1701 DEXTER AVENUE

RECOMMENDATION MEETING

AUGUST 6, 2008

STREET LEVEL / PARKING PLAN (PREFERRED)
NOT TO SCALE

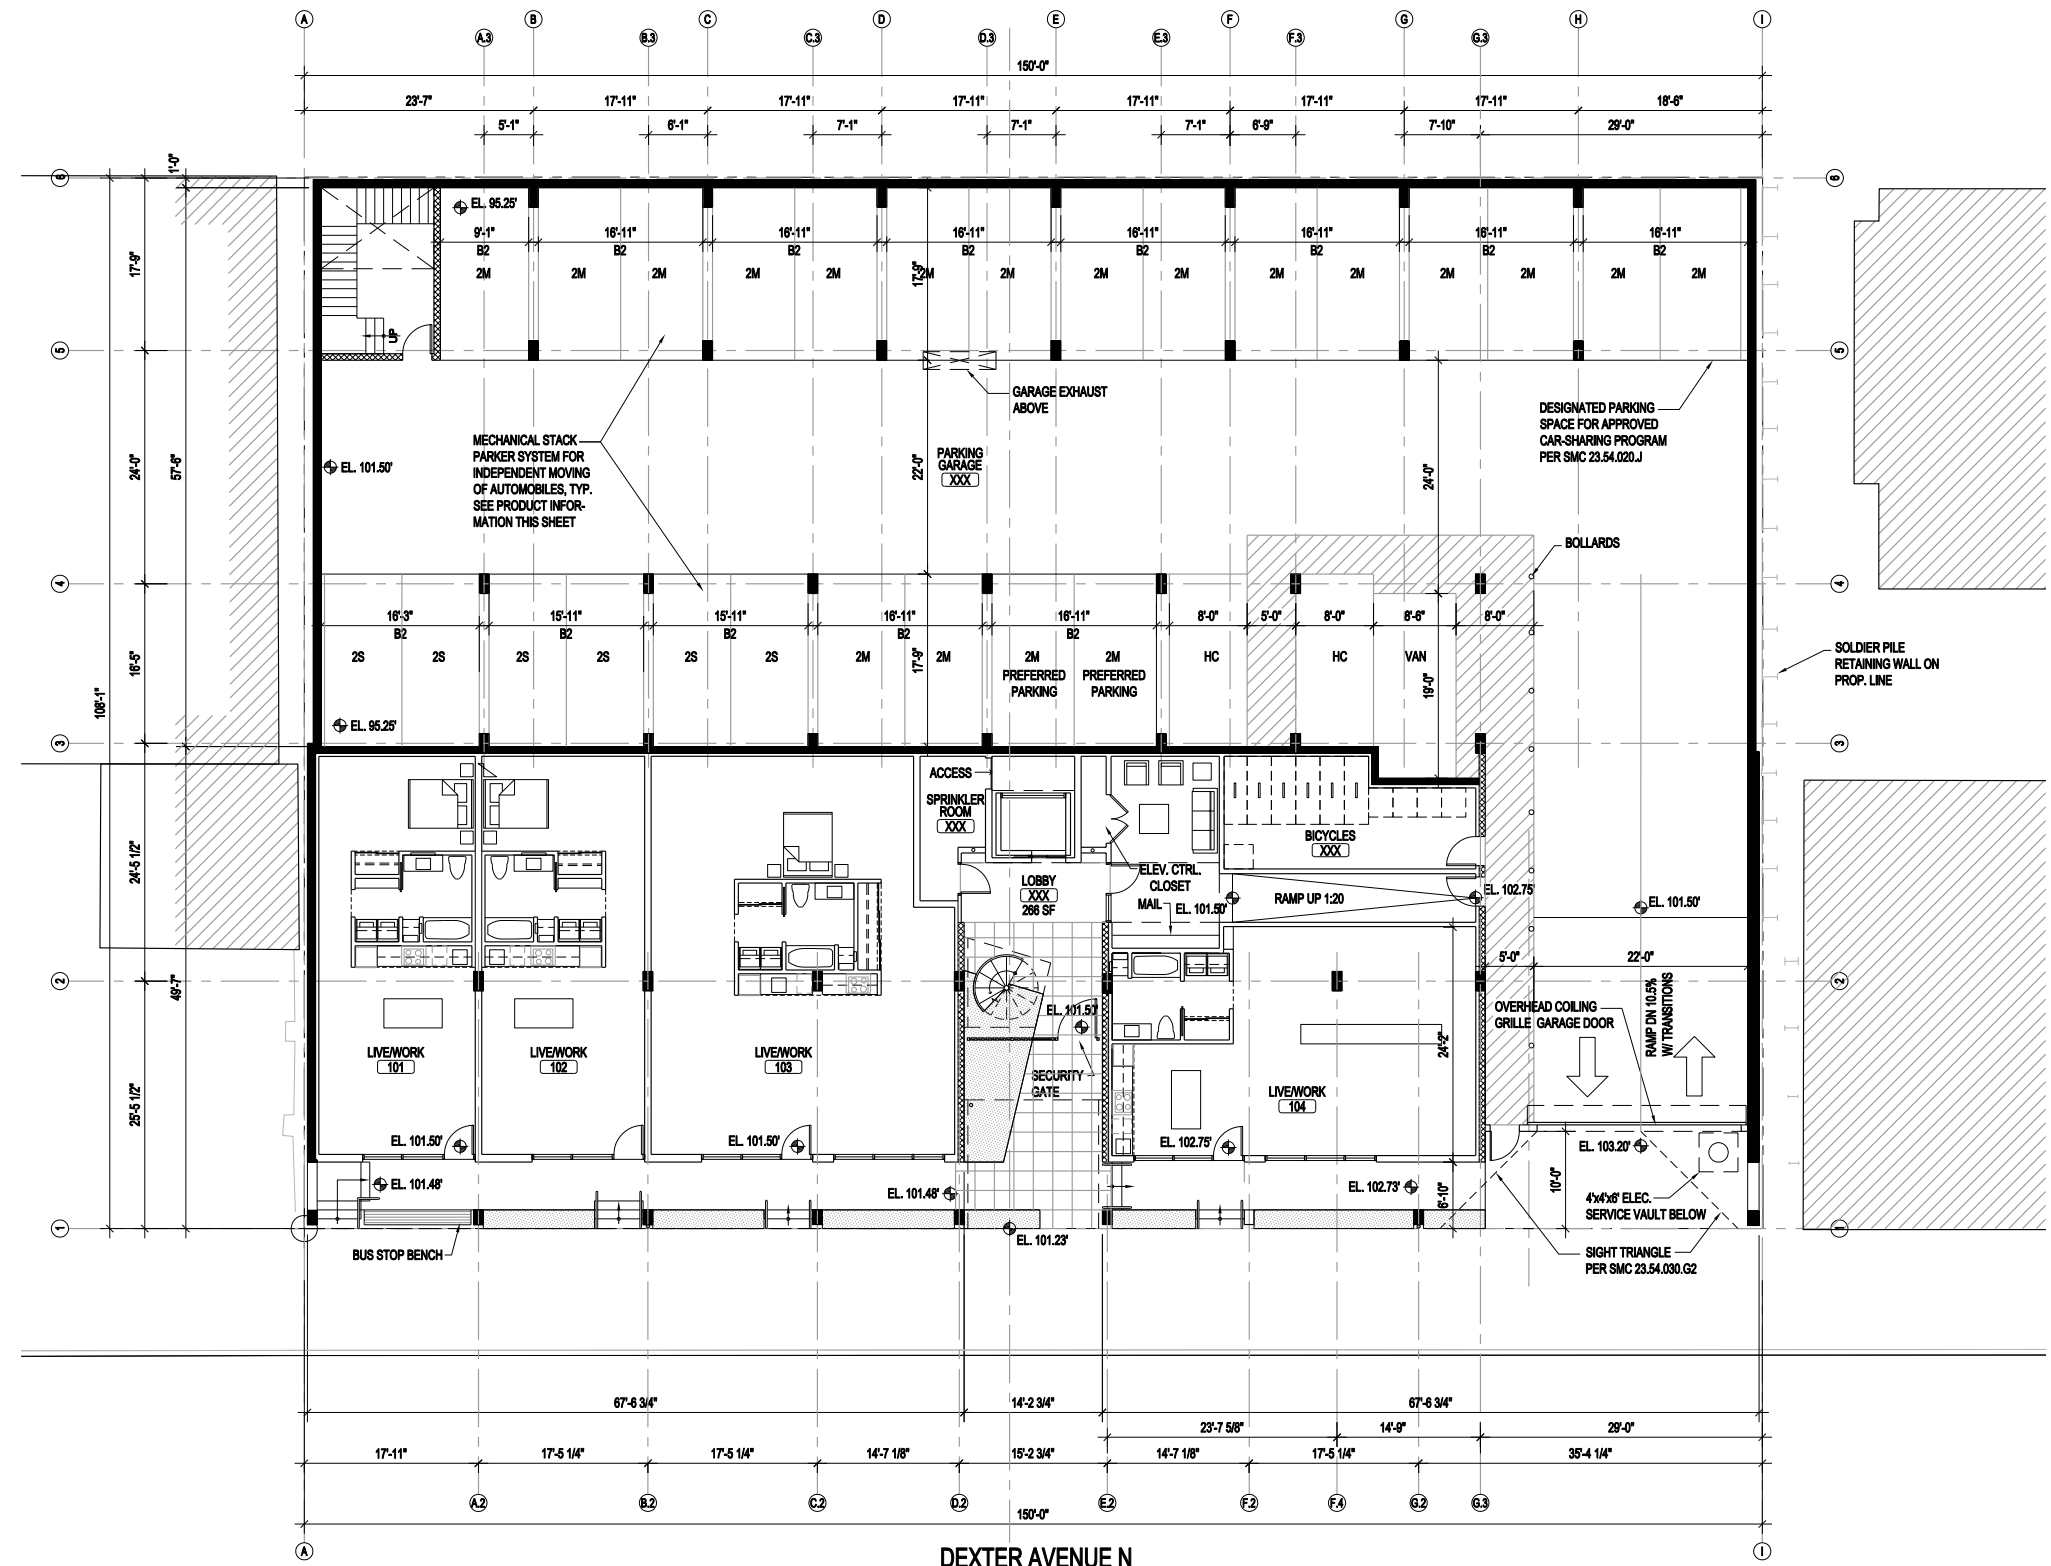
The driveway in and out of the subterranean garage did appear to crowd the neighbor to the north; invariably it would disrupt pedestrian traffic along the sidewalk; it posed a potential safety hazard for southbound bicyclists descending Dexter Ave N., if not for vehicular traffic. Since access from the street would require the Board's recommendation of granting a Design Departure, the Board wanted to see the applicant address more fully issues of appropriateness, functionality and safety. One area of investigation should be studies showing how a single lane in-and-out driveway might better serve the parking garage should a departure be recommended for allowing parking access off Dexter avenue N.

- The garage door entry is set back 10' from the sidewalk. The proposed solution complies with SLUC sight triangle requirements.
- The distance from the garage door to the south bound bicycle lane is 33'. This distance is enough for even a large car to stop for cyclists.
- The garage entry at the northern property line maximizes the distance from the bus stop with its required approach clearances and from pedestrians crossing at the Hayes St. intersection.
- The proposed design shows a 5' wide full height opening at the end of the wall along the north property line to allow a visual connection to the neighboring sideyard space.
- A direct internal connection exists between the garage bicycle parking and the building lobby. No resident pedestrian crossing across the driveway is required.

STREET LEVEL / PARKING PLAN (ALTERNATE)
NOT TO SCALE

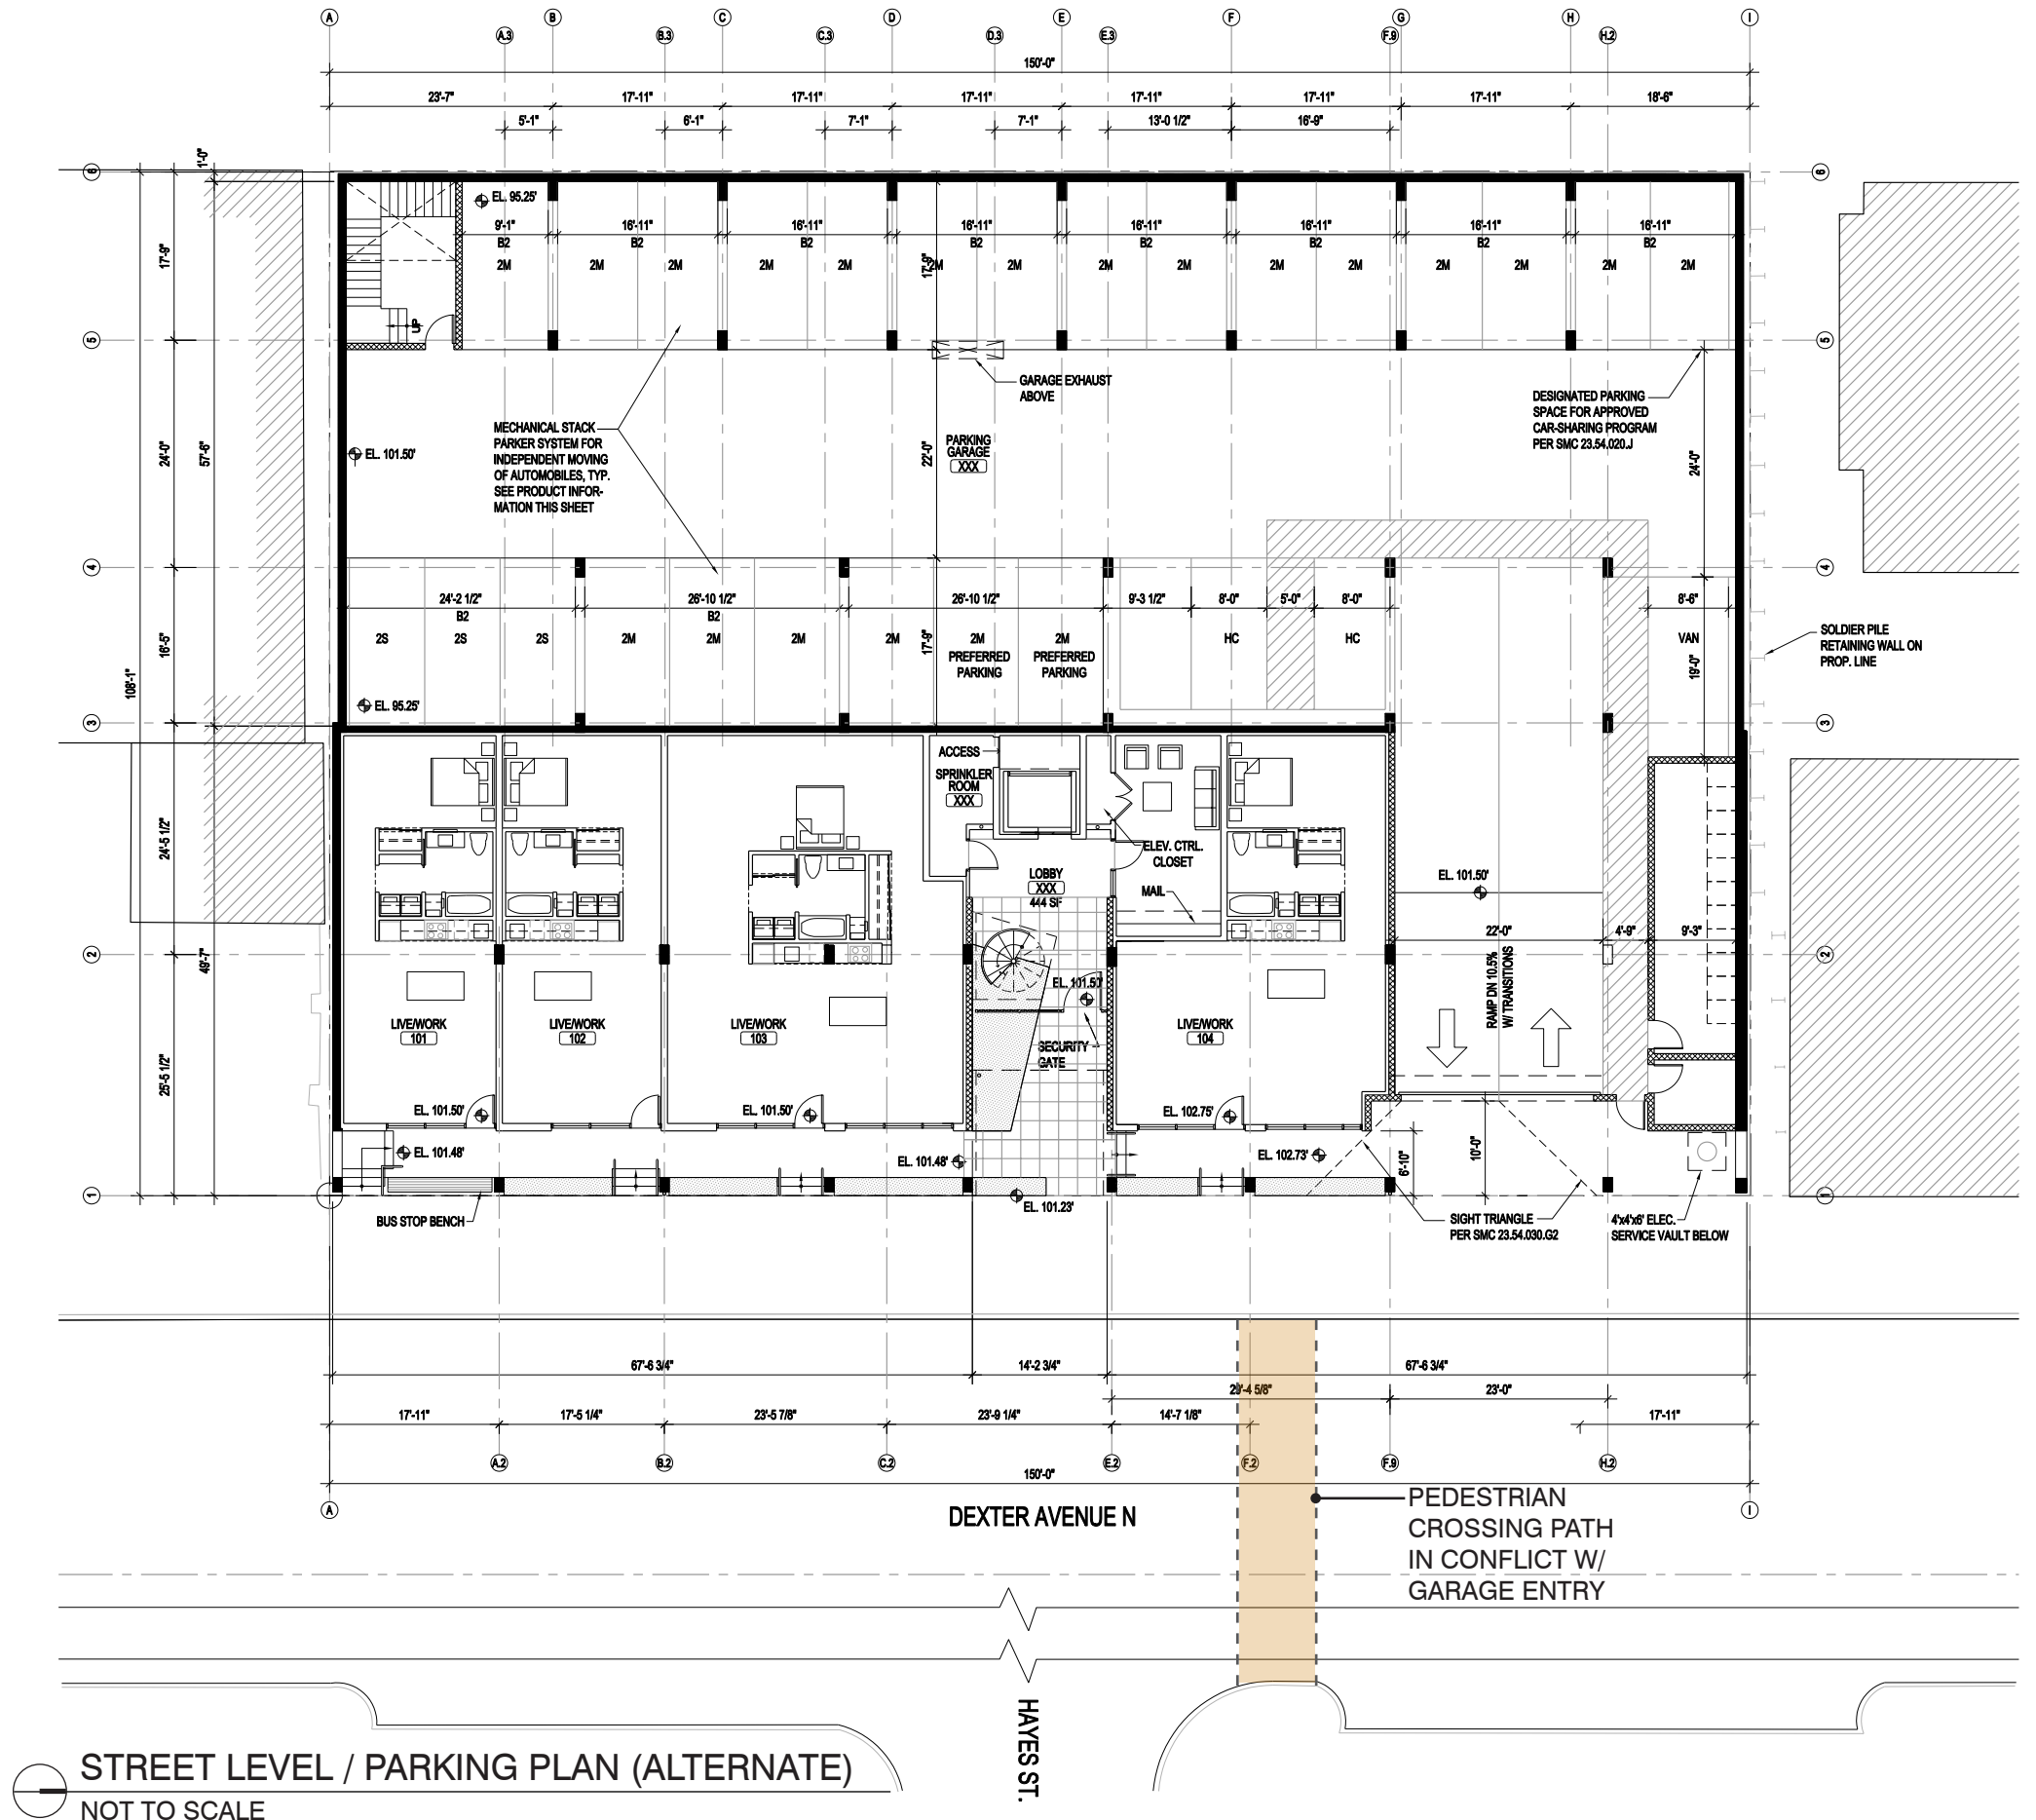
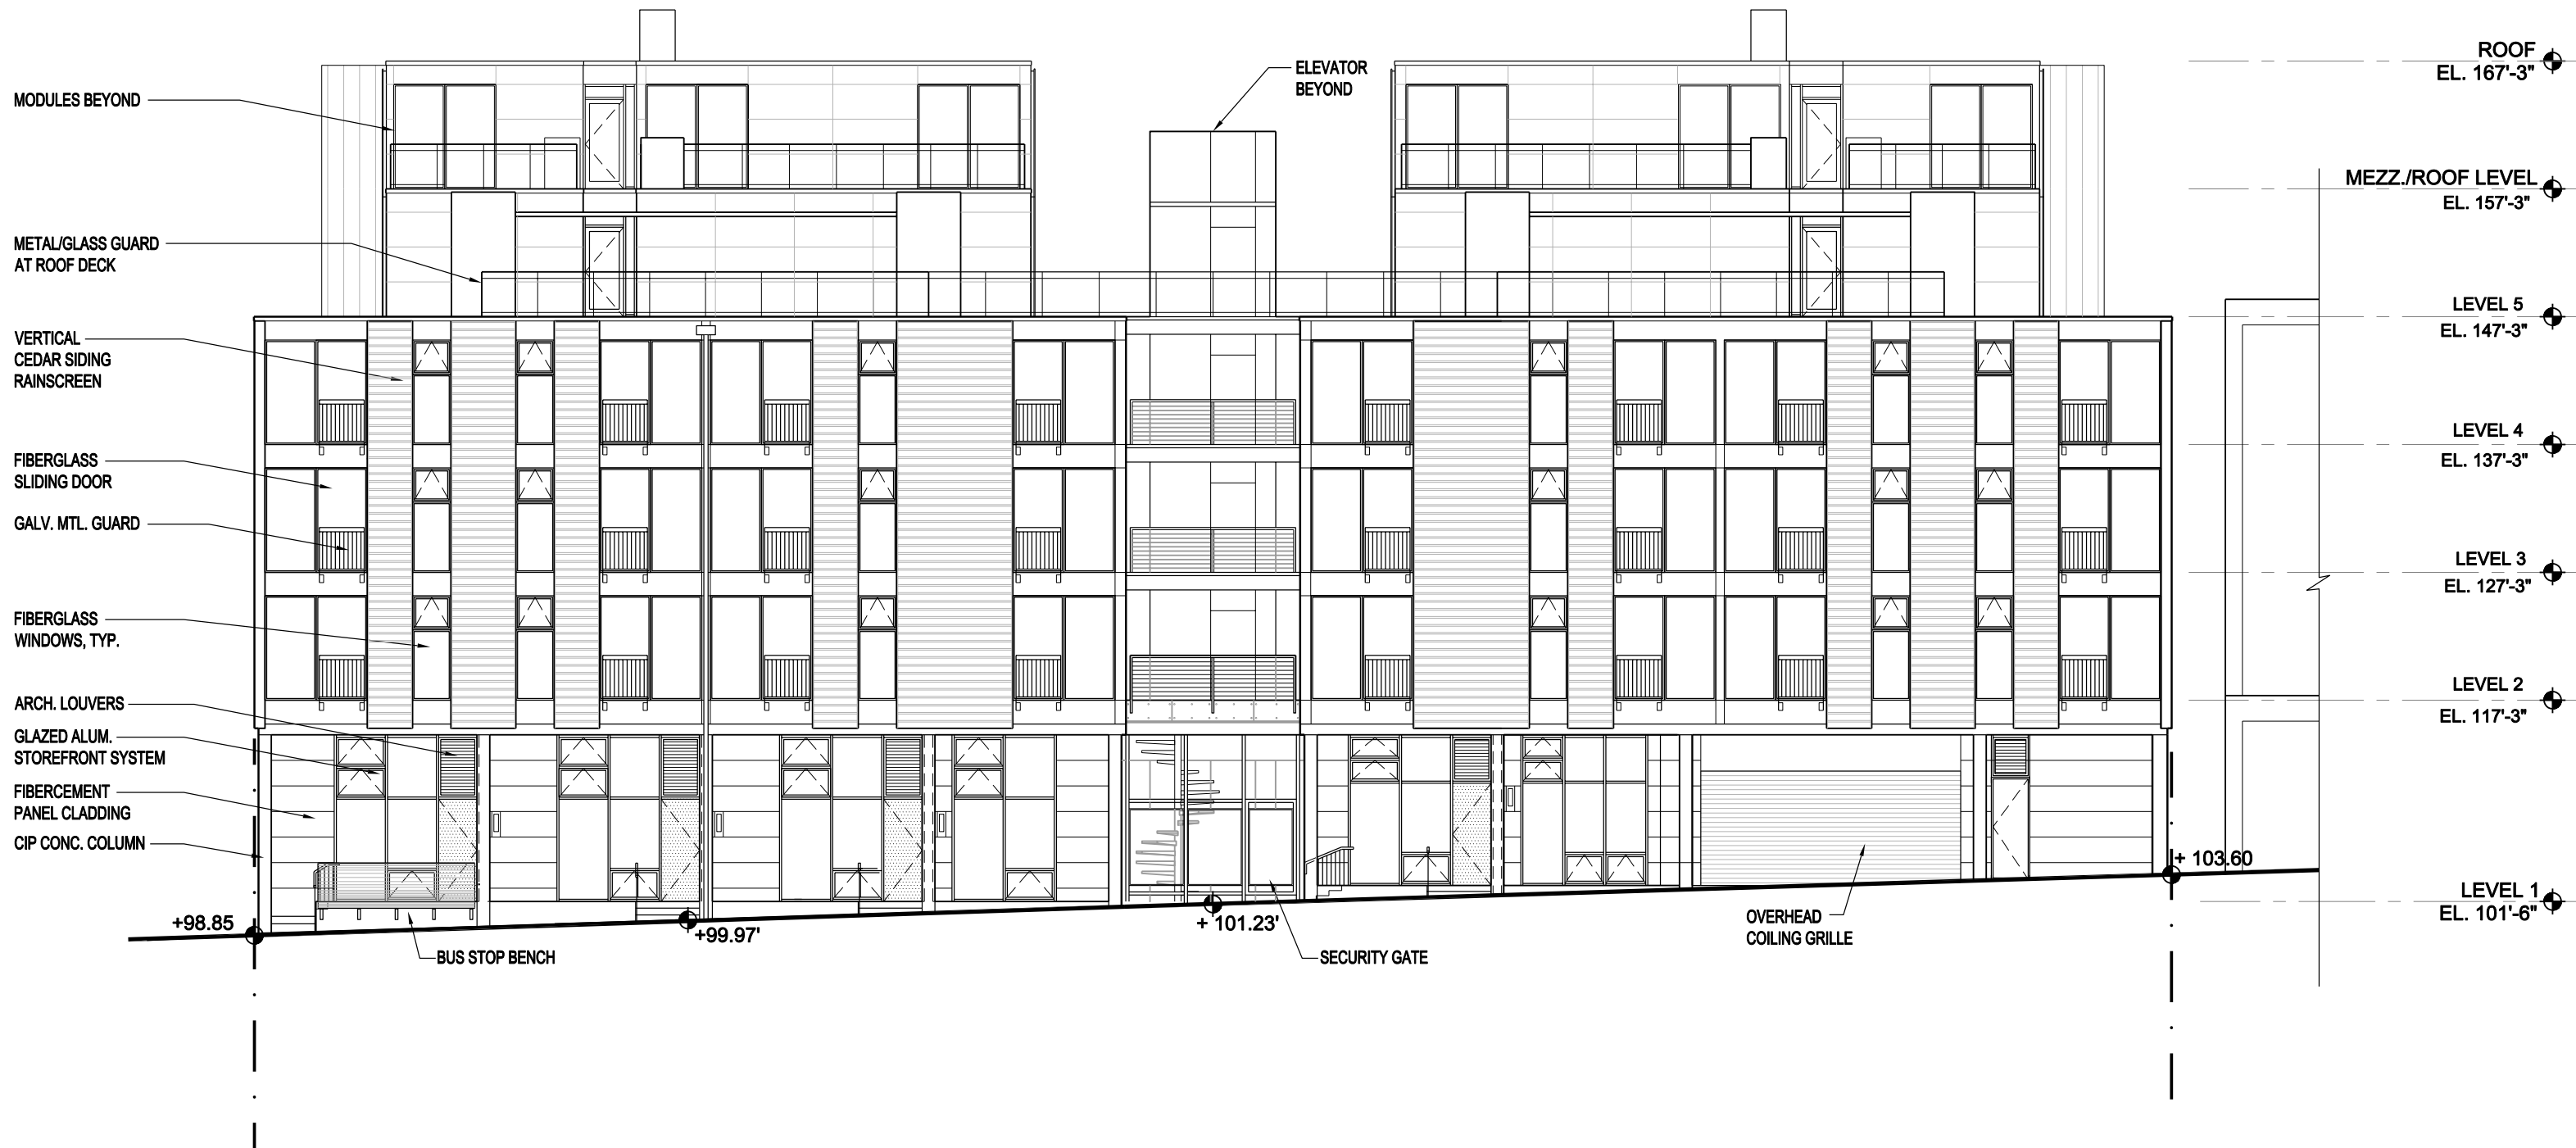
The driveway in and out of the subterranean garage did appear to crowd the neighbor to the north; invariably it would disrupt pedestrian traffic along the sidewalk; it posed a potential safety hazard for southbound bicyclists descending Dexter Ave N., if not for vehicular traffic. Since access from the street would require the Board's recommendation of granting a Design Departure, the Board wanted to see the applicant address more fully issues of appropriateness, functionality and safety. One area of investigation should be studies showing how a single lane in-and-out driveway might better serve the parking garage should a departure be recommended for allowing parking access off Dexter avenue N.

- This alternate shows the driveway shifted approximately 15' to the south with bicycle parking and the garage entrance walkway separating it from the northern property line.
- No internal connection to the building lobby exists. Residents would need to cross the driveway outside which presents a potential safety issue.
- This garage entry presents potential conflicts with pedestrians crossing at the Hayes intersection, creating a safety hazard.
- Ross Hudson, Senior Transit Planner of King County Metro, advised to locate the garage entry as far north as possible to create maximum distance from the bus stop. Diagram to follow.
- The commissioned traffic study advises against a single-lane driveway solution; therefore, this alternative is not presented. Report to follow.
